Technical Service Information

THM 440-T4 REVISED THICKNESS "KOLINE" STEELS

Figure 1

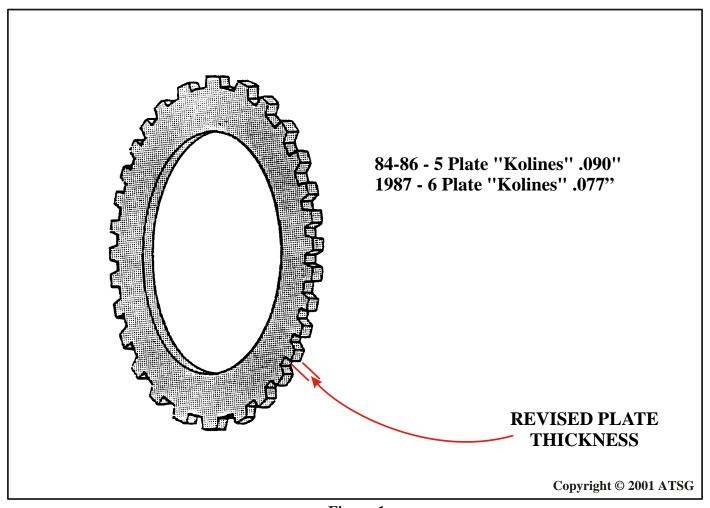
The 2nd clutch steel plates in the 440-T4 are unique, in that they are black in color. They have a black coating on them called "Koline" plating, for shift pleasibility (See Figure 1).

The thickness of the "Koline" plates were revised for the 1987 models, with the addition of the 6 plate clutch pack (See Figure 1).

84-86 - 5 Plate "Koline" Steels	52309
1987 - 6 Plate "Koline" Steels	2006
